#### **Peer Review**

#### Memorandum

Tabor Academy - Synthetic Turf Athletic Field Evaluation

Figure 1: Sampling Locations

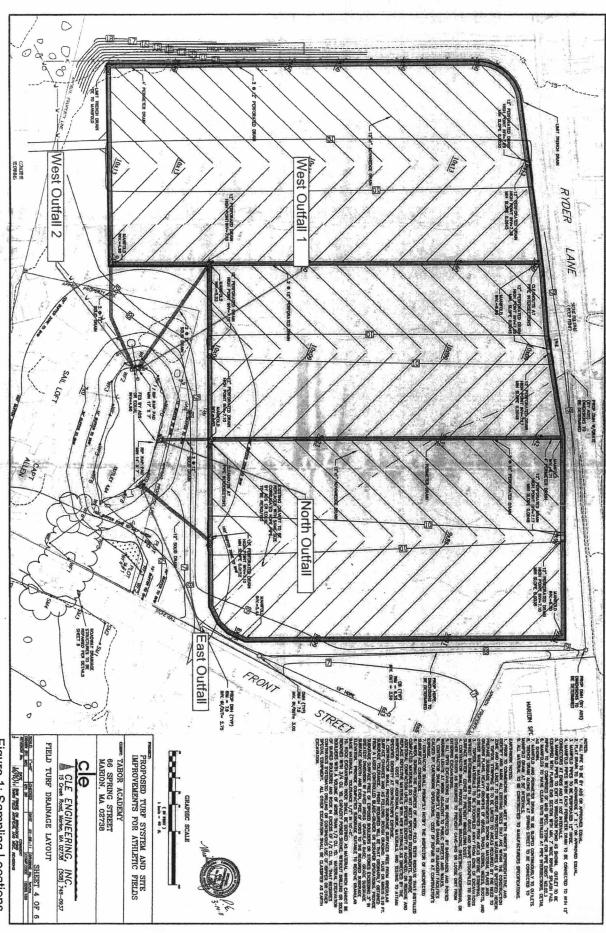
Wet weather samples were taken during four storm events from four outfalls discharging flow to the field's underdrain system. All four outfalls discharge to the pond in the southeast corner of the field as shown in Figure 1. During each rain event, samples for the baseline data were obtained through rainwater collection.
